Santa Catalina Towers Restroom & Deck Renovation
Project No. FM090053S/987711

Addendum No. 4

December 4, 2008

ADDENDUM NUMBER 4
to the
CONSTRUCTION DOCUMENTS

SHOWER STALL PLAN
SHEET T-2

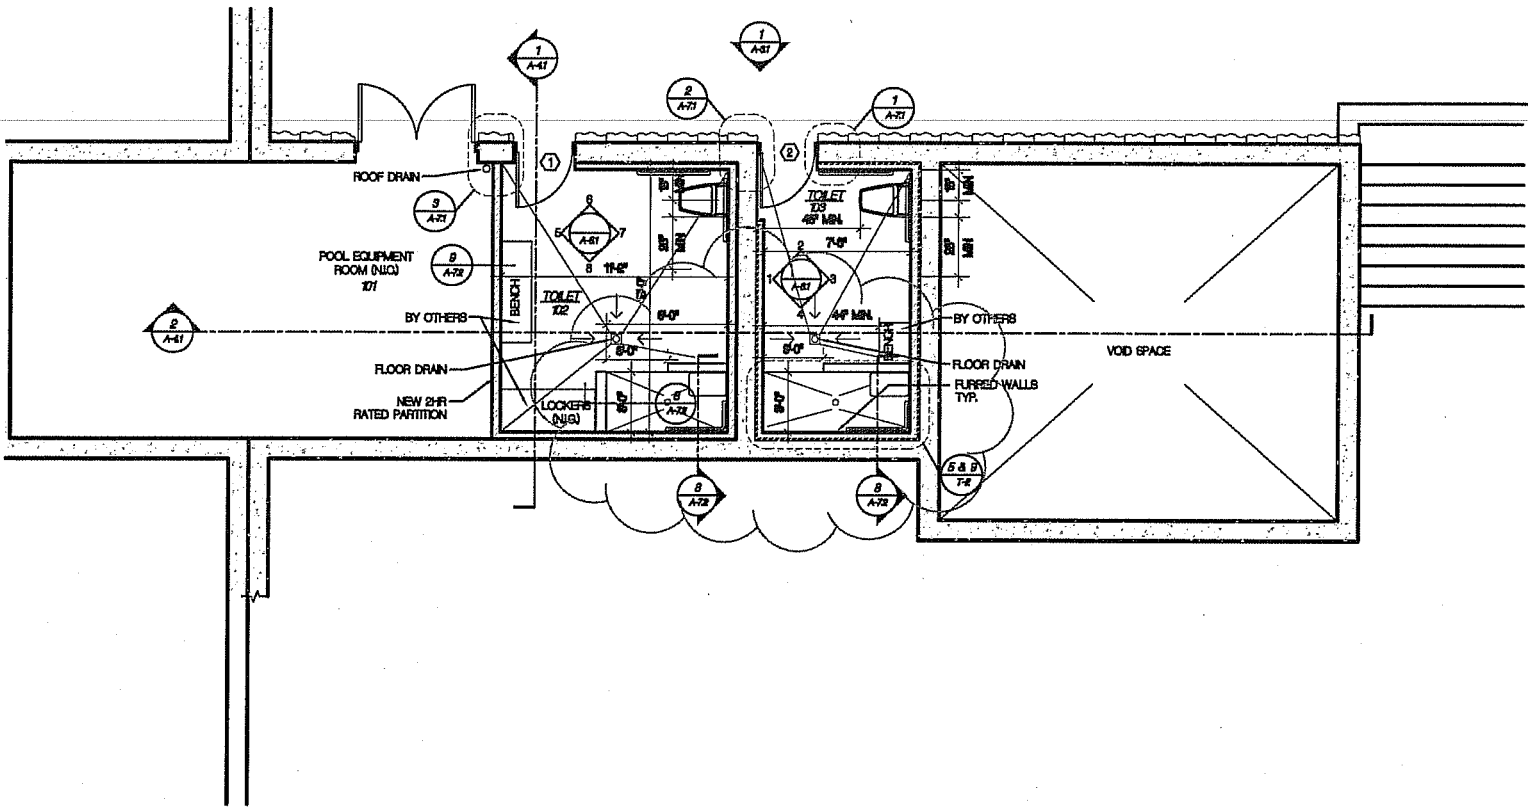
1. Sheet T-2 "A.D.A Details":
Replace Shower Stall Plan Detail 9 in its entirety with attached Revised Detail 9/T-2 (10).
2. Sheet A-2.1 "Floor Plan & Reflected Ceiling Plan":
Replace Floor Plan Detail 1 in its entirety with attached Revised Detail 1/A-2.1 (8).

SHEET A-6.1

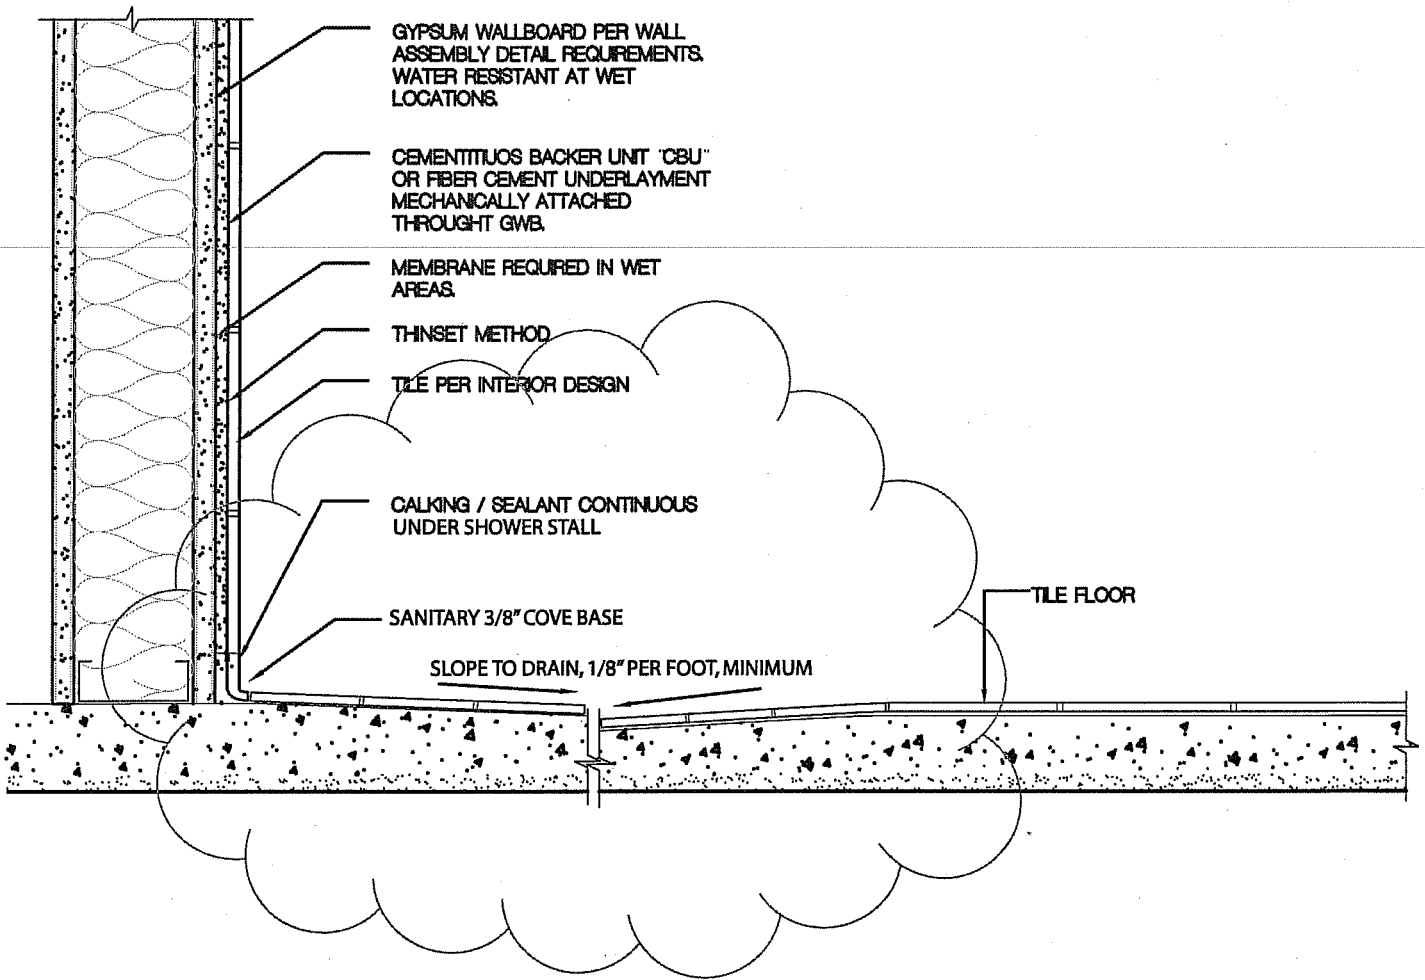
3. Sheet A-6.1 "Interior Elevations":
Replace Elevation Detail in its entirety with attached Revised Elevation for all details on Sheet A-6.1.

USE DAL TILE KEYSTONE
 SELECT #D178 BOMBAY
 3" X 3" OR EQUAL (WALLS
 AND FLOORS), COLOR AND
 GROUT TO BE SELECTED BY
 UNIVERSITY REPRESENTATIVE.
 (TYP.)
